# UNITED STATES PATENT AND TRADEMARK OFFICE

10/573,192

<b>Office Action Summary</b>	<b>Application No.</b> 10/573,192	<b>Applicant(s)</b> HARKINS, PETER WILLIAM	
	<b>Examiner</b> ANDREW T. KIRSCH	<b>Art Unit</b> 3781

## **DETAILED ACTION**

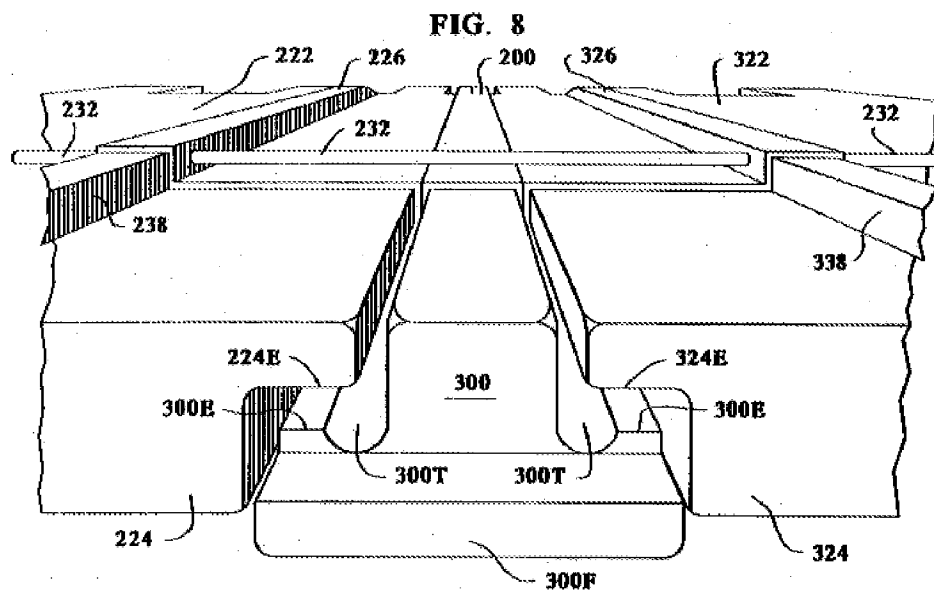
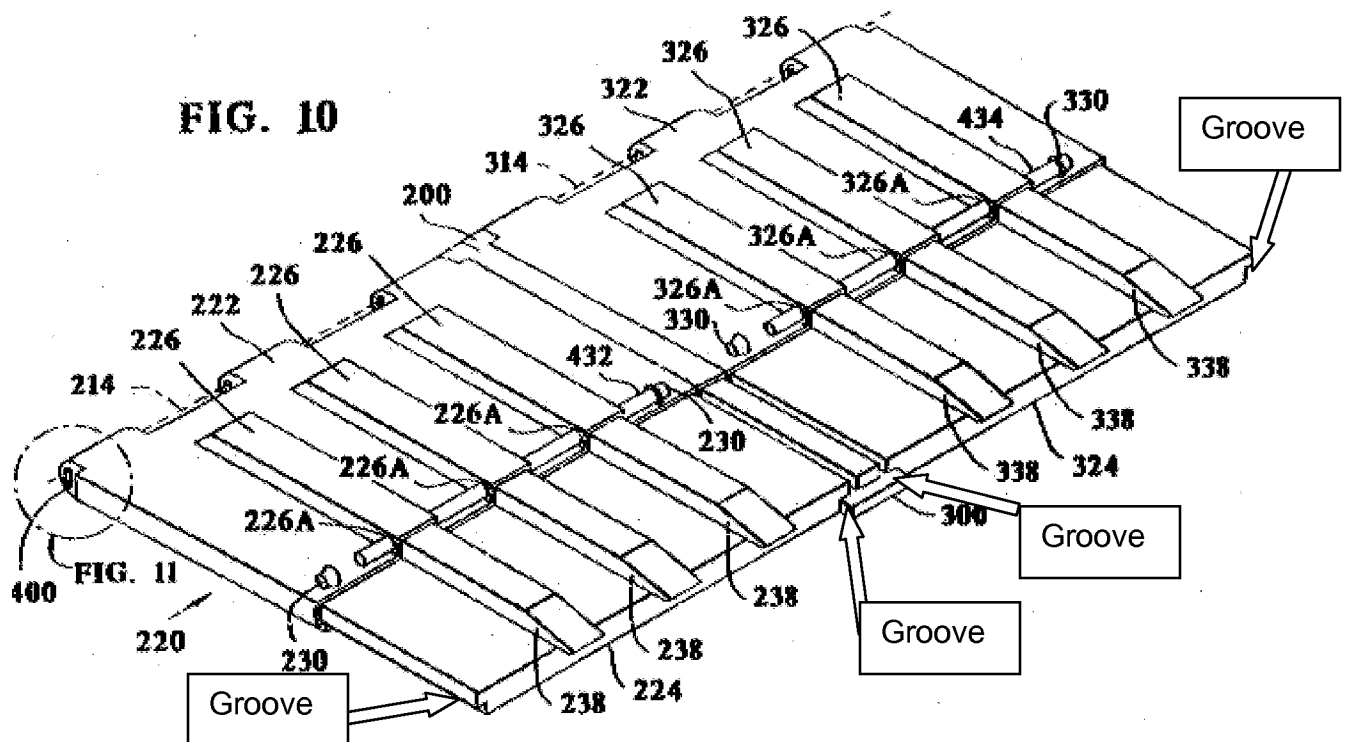
7. In re claim 1, with reference to Figs. 8 and 10 below, Mullett et al. discloses: A closure for a refuse container, the closure including a main panel (200, 300) portion having opposed side edges, the closure further including side members (224, 324), each of which is adapted to be associated with a respective side edge of the main panel portion (see Fig. 8), the side members (222 with 224, and 322 with 324) being of greater rigidity (because the side members are thicker due to 238 and 338, see Fig. 8) than the main panel portion (200, 300), cooperating connector parts (224E, 324E, and 300E) associated with the main panel portion and side members for releasably connecting each of the side members to a respective side edge of the main panel portion (see Fig. 8), and a pivot mounting (400) for pivotally mounting the closure to the refuse container.

8. In re claim 2, with reference to Figs. 8 and 10 above, Mullett et al. discloses the claimed invention including wherein the main panel portion (200, 300) is a generally flat member which is generally rectangular in plan having opposed end ends (at 200, and at 300) extending between the opposed sides, the pivot mounting (400) including a pivot mounting section (400) at one of the ends (at 200).

9. In re claim 3, with reference to Figs. 8 and 10 above, Mullett et al. discloses the claimed invention including wherein each side member (222 with 224, and 322 with 324) of the closure is in the form of an elongated bar shaped element having sides (224E and 324E) which are about the same length of the sides (300E) of the main panel portion (300), each side member including opposed ends (at 222, 224, 322 and 324), and said pivot mounting (400) including a further pivot mounting section (414) at one end thereof.

10. In re claim 4, with reference to Figs. 8 and 10 above, Mullett et al. discloses the claimed invention including wherein the connector parts include a tongue (300E) and cooperating groove (224E and 324E), the tongue being formed on the main panel portion and the groove being formed on the side members.

11. In re claim 5, with reference to Figs. 8 and 10 above, Mullett et al. discloses the claimed invention including wherein two tongues (300E) are provided one extending along each of the sides of the main panel portion (see Fig. 8 above) and each side member includes two grooves (see Fig. 10 above) each formed in a respective side there, the main panel portion (200, 300) and side member (222 and 224) being connectable together by sliding the tongue into the groove at one end thereof (when unhinged).

12. In re claim 6, with reference to Figs. 8 and 10 above, Mullett et al. discloses the claimed invention including wherein the pivot mounting (400) is in the form of a pin receiving sleeve (414) (see Fig. 9) operatively mounted to the main panel portion (see Fig. 11) and/or the side members.

16. In re claim 7, with reference to the Figs. above, Mullett et al. discloses the claimed invention including reinforcement (432 and 434) embedded in the side members (222 and 322) in the region of the pivot mounting sections (400) and embedded within in the side members.

19. In re claim 8, with reference to the Figs. above, Mullett et al. discloses the claimed invention including wherein the metal reinforcement (432, 434) is associated with the side members (222 and 322) and includes spaced apart side bars (432, 434) with a sleeve (226A) extending between the side bars at one end thereof the sleeve (226) defining the pin mounting sleeve (inside which the shaft 432 is mounted) and a cross rod (214) extending between the side bars at the other end thereof (the end of 226 closer to the pivot section 400).
